PRO :		:		:	
		P OF S R :			
R PR S :		S BM B :		:	
R:		PPRO B :		:	
O R OR:		OR R O.:		:

High Purity RO/DI Water Skid

Shop Drawing Submittal Review

PROJECT NAME: Webster University ISB
LOCATION: St. Louis Missouri
CLIENT PROJ. No.: N/A
WES PROJ. No.: 607
SPEC SECTION: 22 6700 Processed Water System for Laboratory Facilities
SUBMITTAL ITEM:: See Below -

M10-3

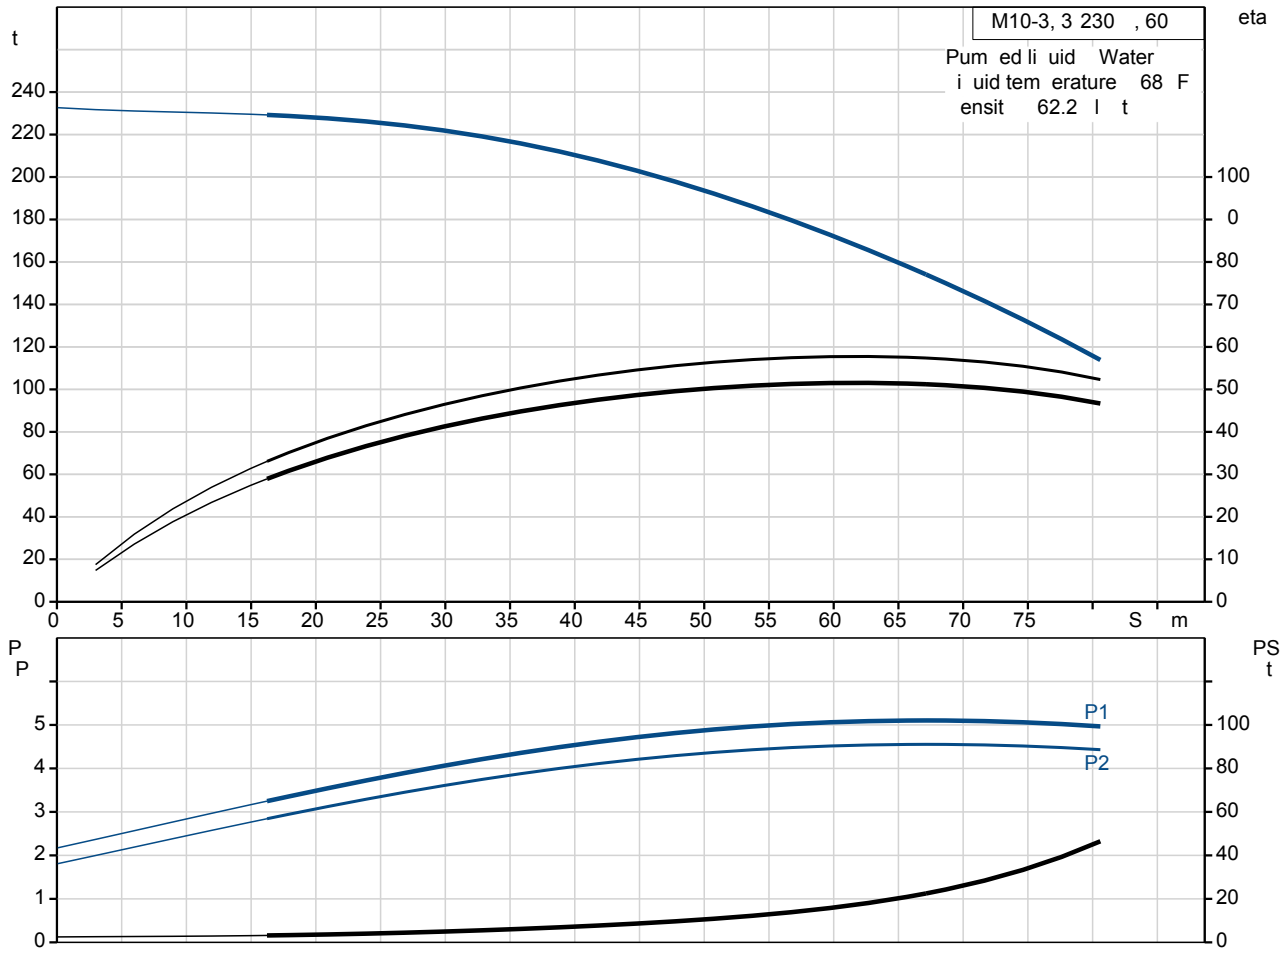
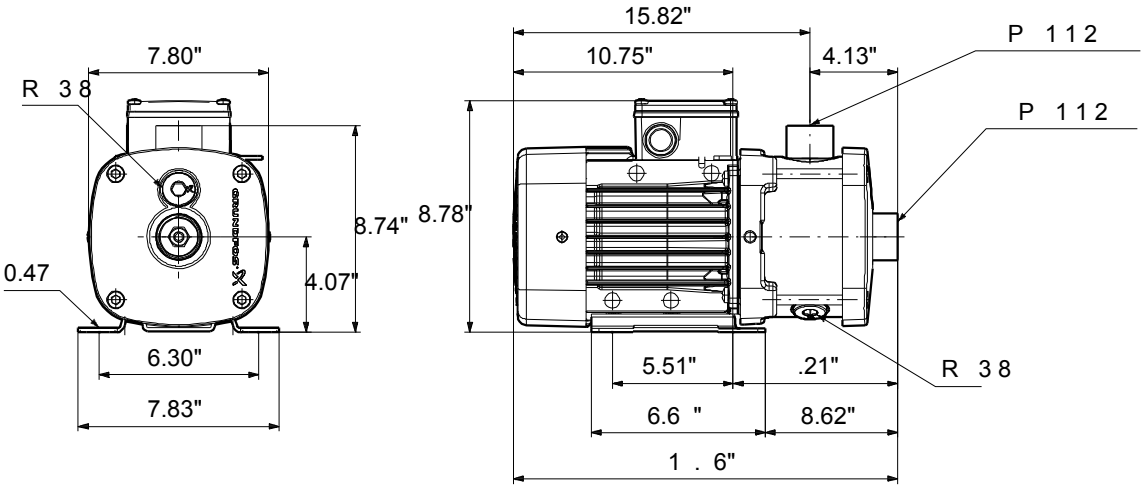
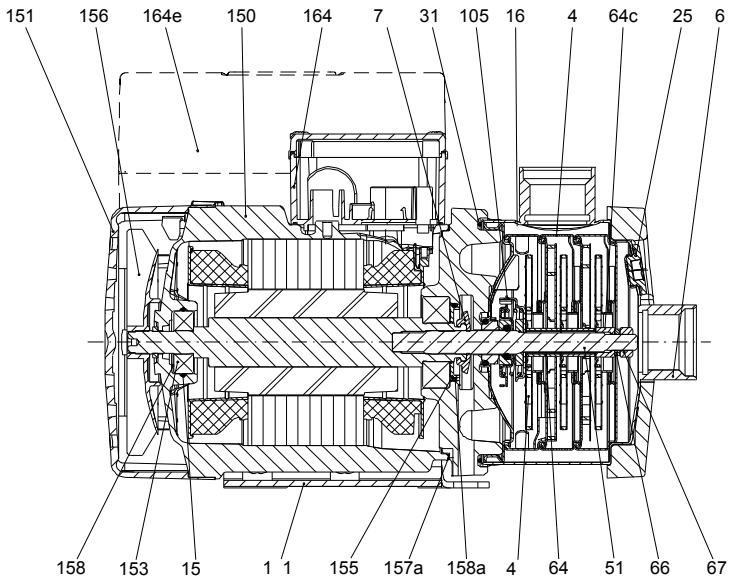
1. Verify correct size and capacities of pumps and motors.
2. Motor starter control panel not included in submittal.
Refer to specification section 226700, Pat 2.2, paragraph 7a

M10-3

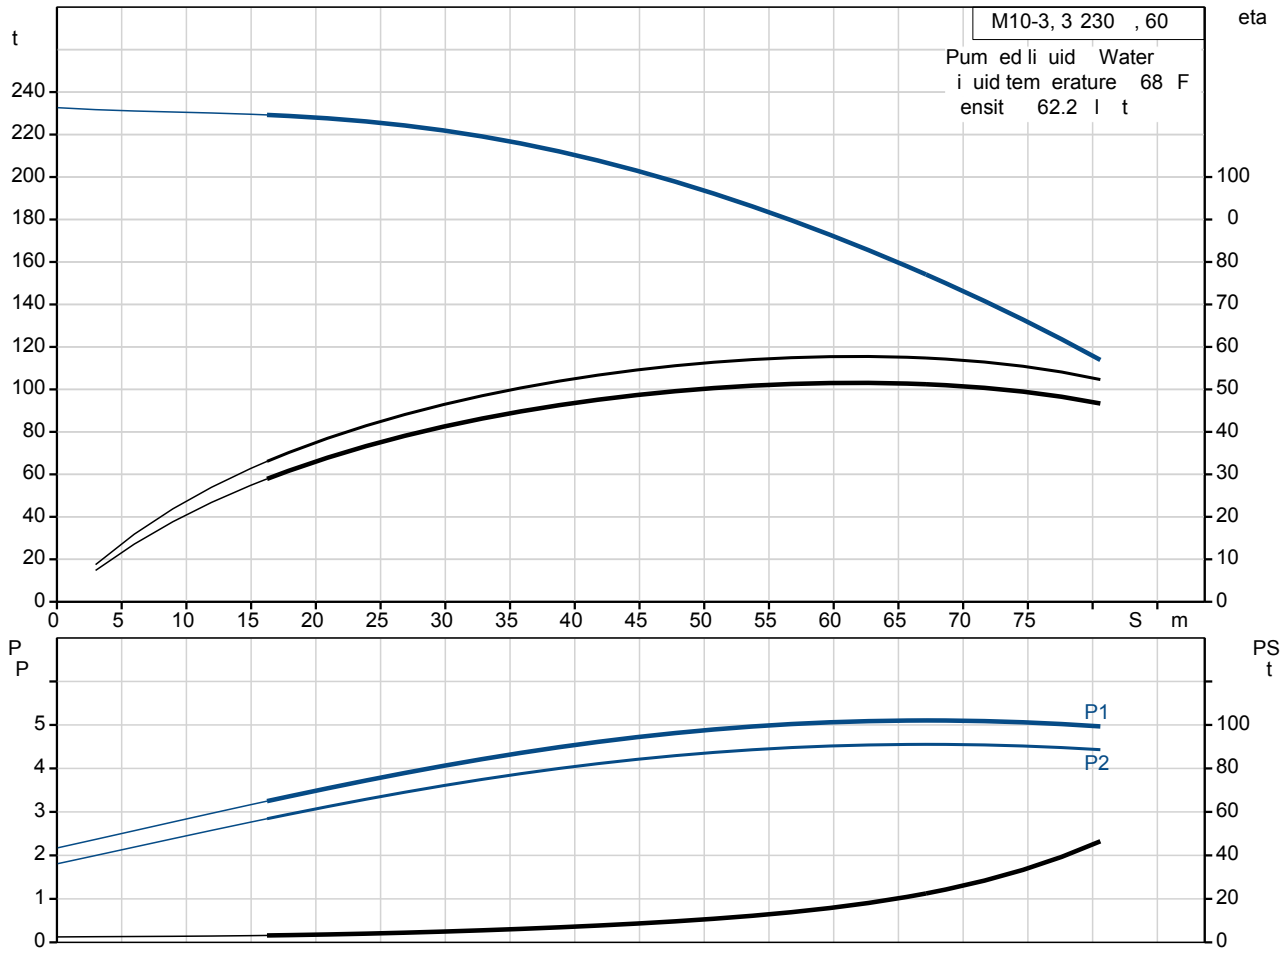
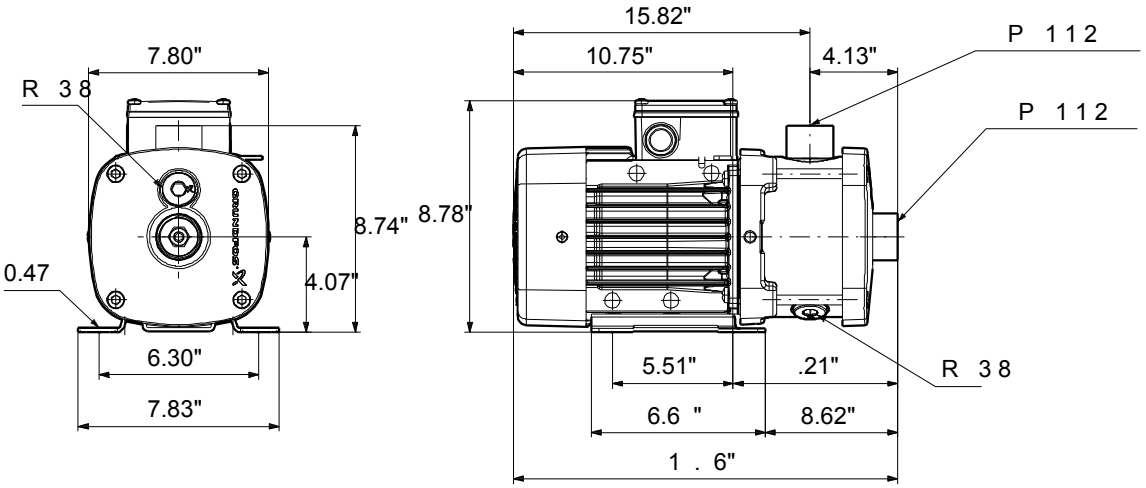
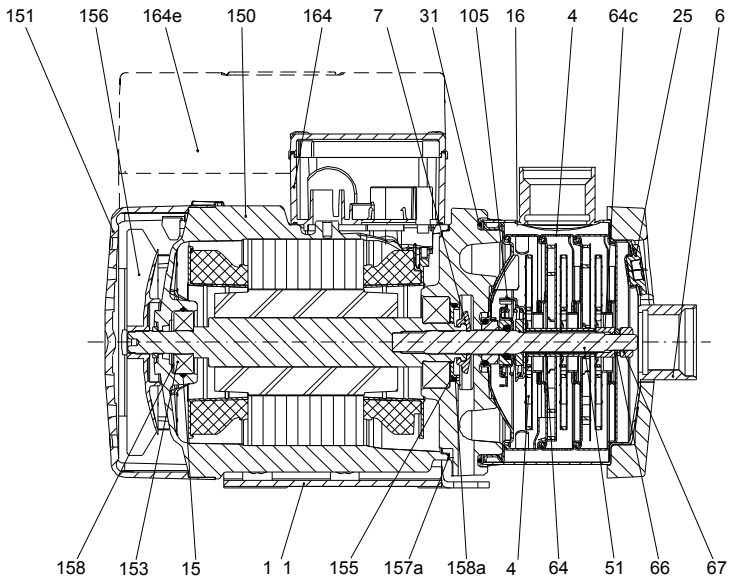
1. Verify correct size and capacities of pumps and motors.
2. Motor starter control panel not included in submittal.
Refer to specification section 226700, Pat 2.2, paragraph 7a

1. Pumps rated for 35 GPM at 95 psi. Exceeds pump and pressure requirements on P&ID.
2. Complete Electricals available 2-3 weeks after release of order.
